Comments on NorthWestern Energy's Final 2019 Electricity Supply Resource Procurement Plan

Prepared for Montana Public Service Commission

February 14, 2020

Synapse
Energy Economics, Inc.

Figure 4. NorthWestern’s new resource costs for renewables and batteries

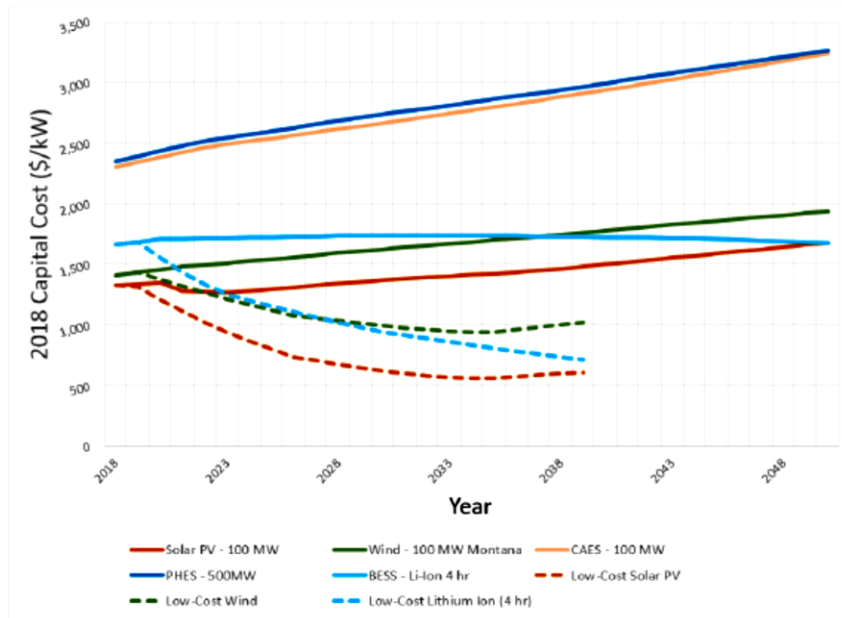
NorthWestern’s response to these comments is that the original Base Case was re-run with the lower cost trajectories for these resources, and these lower cost futures had no effect on the resource selection. Therefore, NorthWestern chose not to include these resources, at these lower costs, as an option in future scenario modeling.¹¹ This is flawed, as described below.

At a minimum, it would have been useful for NorthWestern to model the portfolios that fix the additions of renewable and storage resources using the lower cost trajectories. The Li-ion Battery portfolio has a revenue requirement that is only \$15 million more than NorthWestern’s Base portfolio under reference capital costs. A lower capital cost for battery storage technologies would lower the revenue requirement associated with that particular portfolio, perhaps bringing the cost below that of the Base portfolio.

Figure 5. PowerSimm portfolio setup

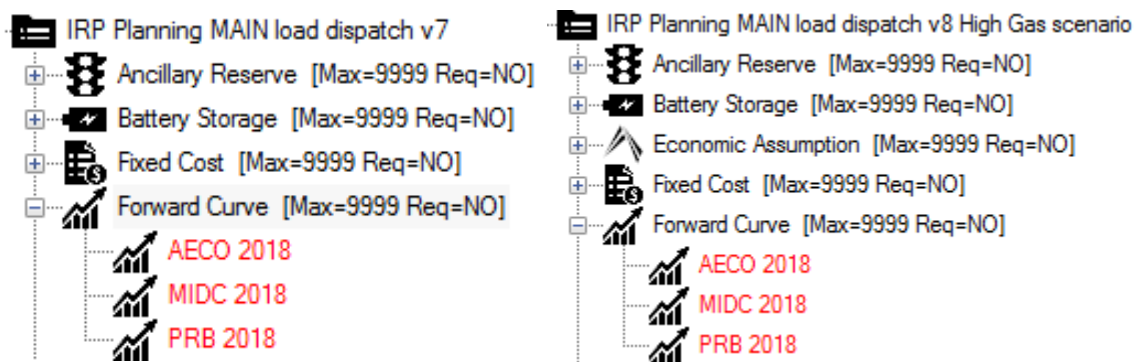
NorthWestern claims in the Final Plan that it modeled a High Natural Gas Prices Scenario, which contains all of the assumptions included in the Base portfolio but escalates gas prices at 150 percent of the Base case escalation. The Company also claims that, as in the Base portfolio, resources were added to the portfolio using constrained ARS analysis.¹³ However, upon looking at the setup of the PowerSimm model, Synapse noticed that there was no High Gas Price capacity expansion portfolio, meaning PowerSimm would be unable to run a constrained ARS analysis with this new sensitivity (see Figure 5, in which there is a “load dispatch” study for a High Gas scenario, but no “HDRCapital” study). Additionally, the load dispatch portfolio labeled as the “High Gas scenario” uses the same forward price curve (AECO 2018) for natural gas as the Base scenario, as opposed to using prices 150% higher than the Base scenario as stated in the Plan (see Figure 6). For these reasons, we believe that NorthWestern did not actually model a High Natural Gas Price scenario despite describing one in its plan.

NorthWestern states that “The High Natural Gas Prices scenario had no effect on resource selection.”¹⁴ However, we cannot know this with any certainty given that this scenario was not actually included as an optimized run in PowerSimm. Additionally, the net present value of revenue requirement (NPVRR) for the High Natural Gas scenario is shown as being approximately \$3 million less than the Base portfolio, for which NorthWestern has not provided an explanation.

Figure 8: Solar fixed O&M cost comparison

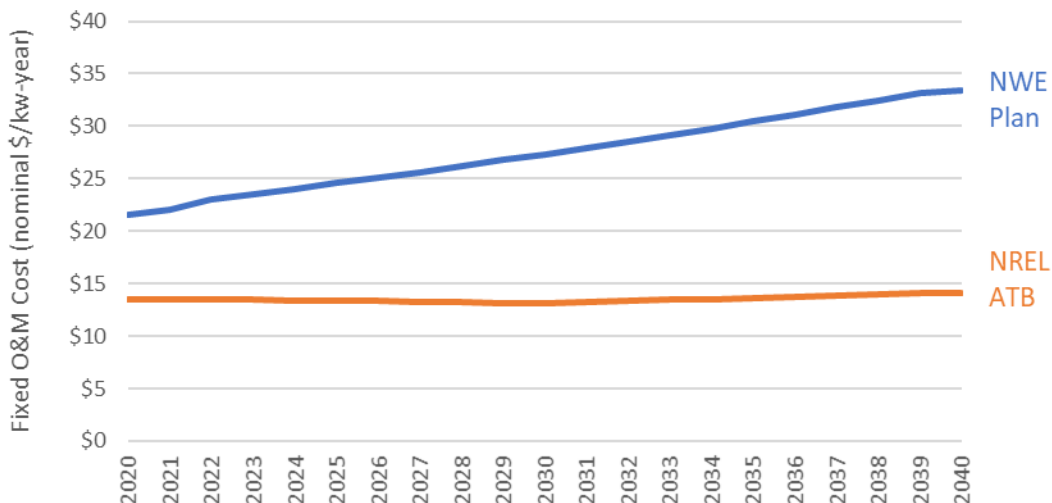
The solar resource fixed O&M assumptions in PowerSimm used in NorthWestern’s IRP modeling were unreasonably high, at \$21.60/kW-year for a new 100 MW solar installation.¹⁸ Lazard’s Levelized Cost of Energy study from 2019, which was referenced by several stakeholders in their comments on the Draft Plan, estimates that utility-scale solar PV Fixed O&M costs are between \$9–\$12 per kW-year.¹⁹ NREL’s 2019 ATB estimates 2019 Fixed O&M costs to be about \$13 per kW-year²⁰ with costs continuing to decline in real terms over time. This means that industry standards are about two-times lower than

what NorthWestern assumes in its plan. A comparison between NorthWestern’s assumption and the NREL 2019 ATB is shown in Figure 8.

This assumption is an important one because the PowerSimm model considers capital, fixed, and variable costs of new resources in its optimization. A high fixed cost is one more disadvantage unreasonably given to solar resources by NorthWestern, in addition to higher capital costs and a capacity credit of zero.
